STAFF REPORT: APRIL 12, 2023 MEETING

APPLICATION NUMBER: 23-8285

ADDRESS: 1444 EDISON

SCOPE: INSTALL VINYL WINDOWS, ENTRY AND STORM DOORS, GARAGE DOORS, INSTALL VINYL SIDING ON GARAGE (WORK COMPLETED WITHOUT APPROVAL), INSTALL GLASS BLOCK/BRICK-IN BASEMENT WINDOWS – *4/12/2023 – staff report revised to include new entry door and installed vinyl windows at side elevations and front elevation dormers*

Staff photo, March 28, 2023.

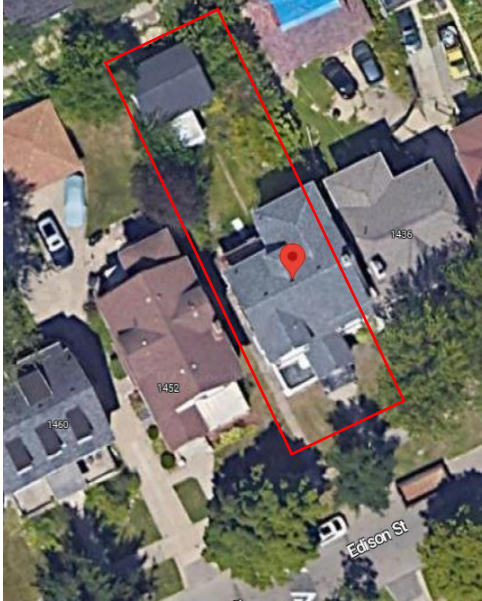
Erected in 1917, the 2-1/2 story house is faced with variegated dark reddish brown and black brick. The verticality of the structure is emphasized by the raised basement and the two-story bay and box bay windows that appear to extend beyond the roofline due to the aligned gable and recessed shed dormers. Aluminum siding covers the dormer walls. Soldier courses at the tops and bottoms of the window openings continuously circle the four sides of the structure, with stone sills installed at the front elevation. Historic window sash remains in the basement window openings, at the second floor of the rear elevation, as well as a leaded glass window on the west side elevation within the small stucco extension. The remaining openings are filled with vinyl replacement units of varying operation, size, and glass configuration.

The centrally placed front entrance is accentuated by a gabled roof that is supported by brick columns. Decorative beams and triangular knee braces are located under the wide, flat rake boards at each gable. An open porch extends to the west of the front entrance, and is enclosed with low height brick walls. Ventilation openings, consisting of three vertical openings supported by thick stone headers and narrow sills, are centrally placed on each porch wall. Horizontal and vertical soldier courses and corner cast stone pieces frame each ventilation opening, and a protruding scupper further accentuates the front-facing wall.

Staff photo, April 4, 2023

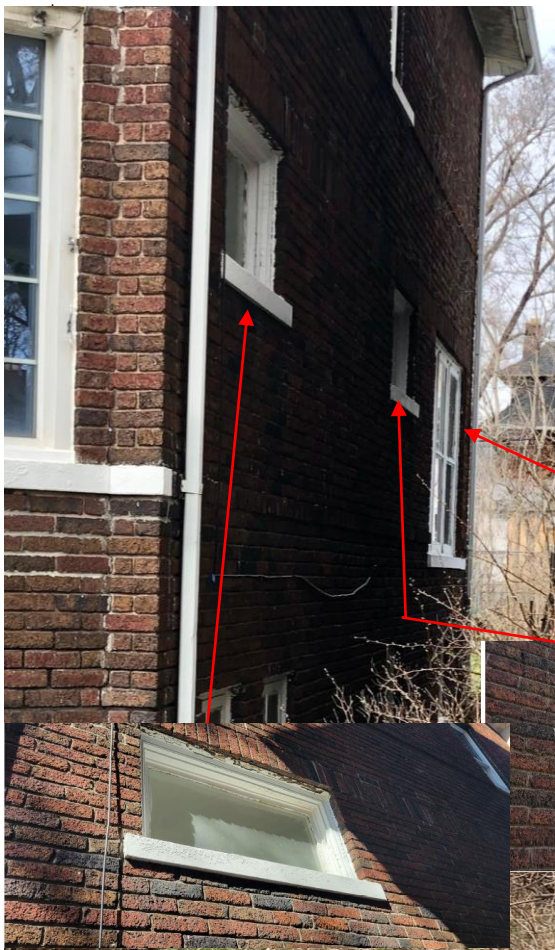
West Elevation
 Historic sash at second floor
 Vinyl replacement windows at first floor

East Elevation
 Historic window units remain at the first floor which include two single opening, fixed windows and a mulled triple double-hung window opening near the rear elevation.
 Vinyl replacement windows are at the second and third/attic floors.
